State of New Mexico
 Energy, Minerals and Natural Resources

Form C-103
 Revised July 18, 2013

WELL API NO. 30-025-49806
5. Indicate Type of Lease STATE ☐ FEE ☒
6. State Oil & Gas Lease No.
7. Lease Name or Unit Agreement Name Mandelbaum Fee
8. Well Number 126H
9. OGRID Number 372043
10. Pool name or Wildcat RED HILLS;BONE SPRING, NORTH
4. Well Location Unit Letter <u>O</u> : 1029 feet from the <u>South</u> line and <u>2462</u> feet from the <u>East</u> line Section <u>11</u> Township <u>24S</u> Range <u>34E</u> NMPM County <u>LEA</u>
11. Elevation (Show whether DR, RKB, RT, GR, etc.) 3487 GR

Tap Rock Operating, LLC is requesting permission to alter the drilling plan for the Mandelbaum Fee 126H. Tap Rock would like to alter the bottom hole location for this well from:

WELL LOCATION AND ACREAGE DEDICATION PLAT

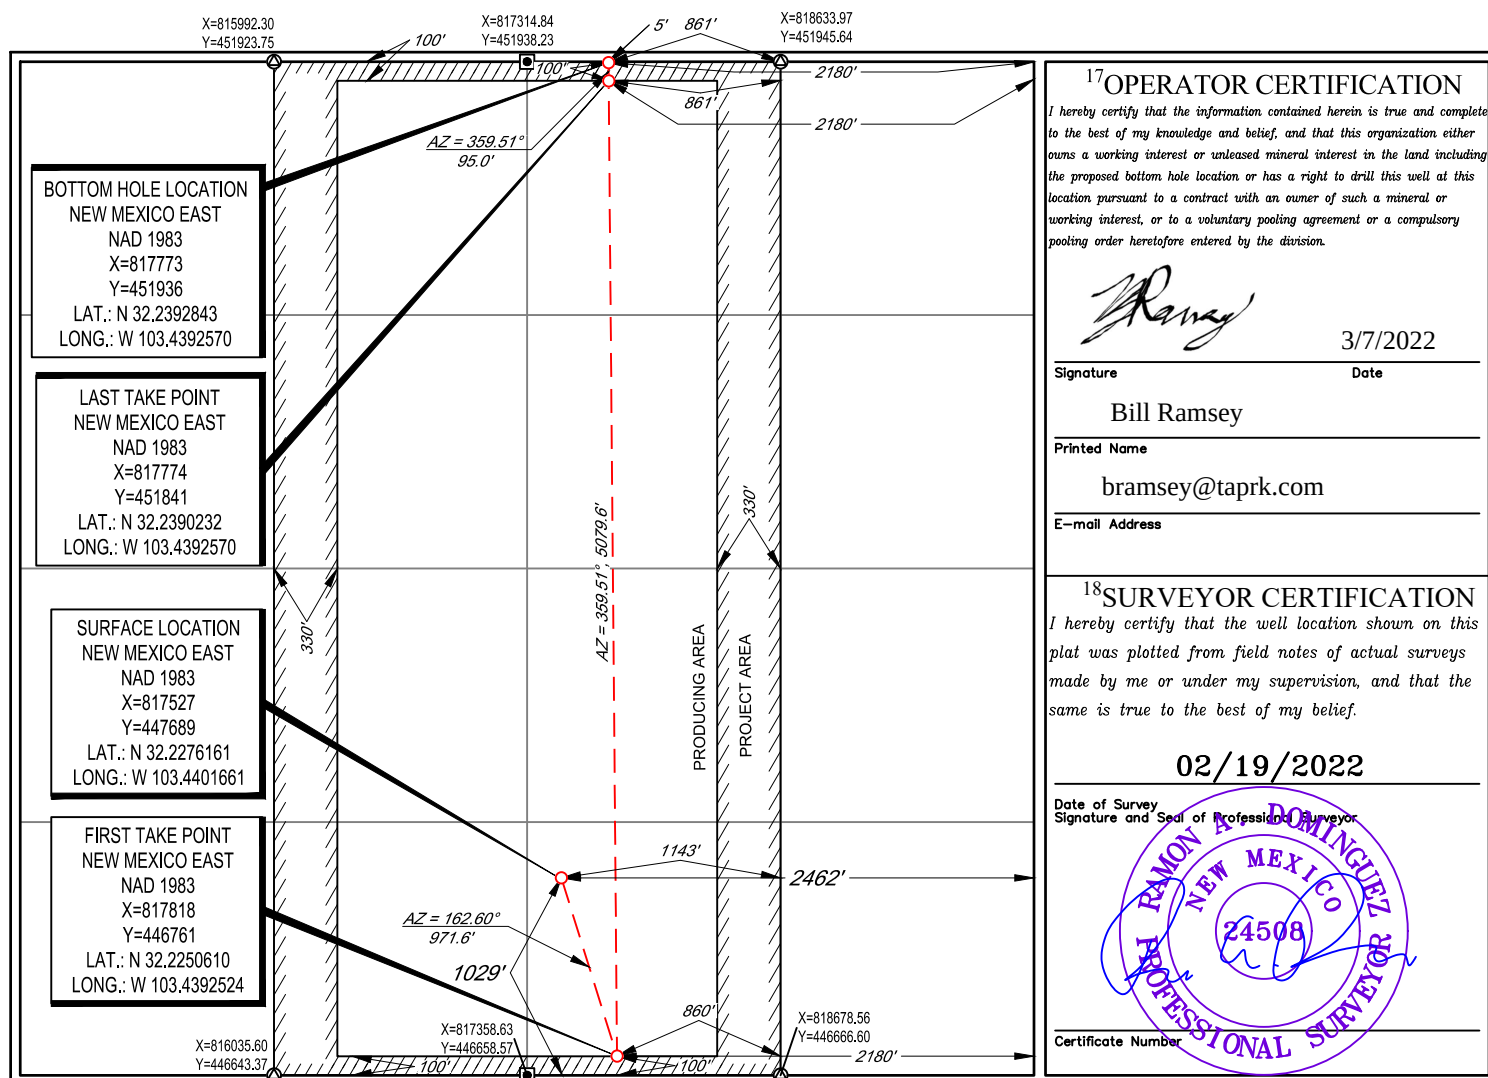
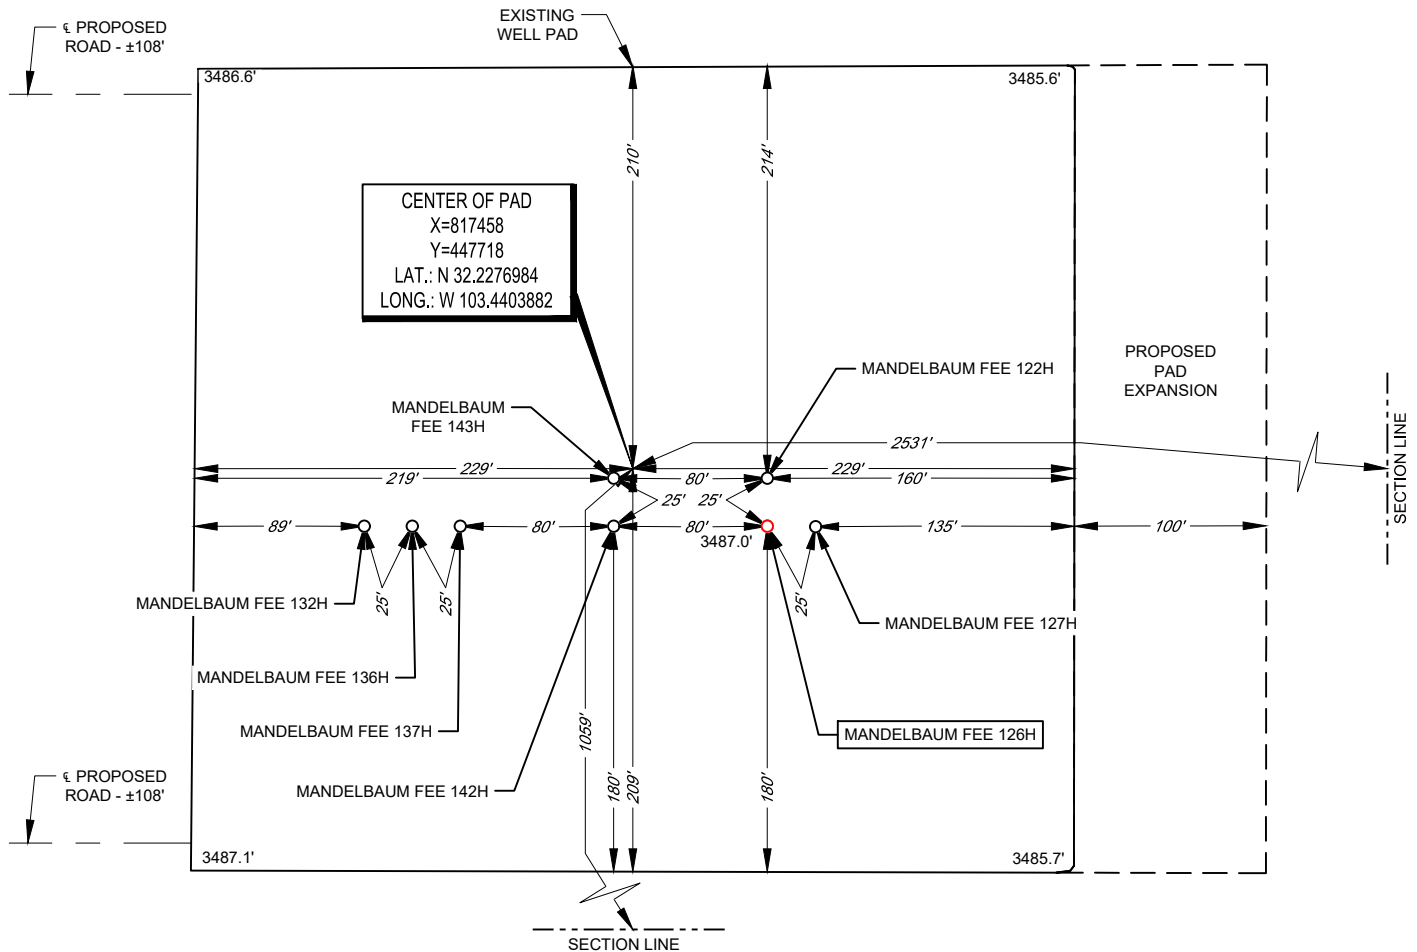
Previously approved BHL: 5' FNL 1980' FEL, Section 11, Township 24S, Range 34E
 Requested new BHL: 5' FNL 2180' FEL, Section 11, Township 24S, Range 34E

Tap Rock would also like to alter the production hole size from the previously approved 6.75" hole to a 7.875". An updated casing table, drill plan, and plat can be seen below/attached.

UL or lot no.	Section	Township	Range	Lot Idn	Feet from the	North/South line	Feet from the	East/West line	County
B	11	24-S	34-E	-	5'	NORTH	2180'	EAST	LEA
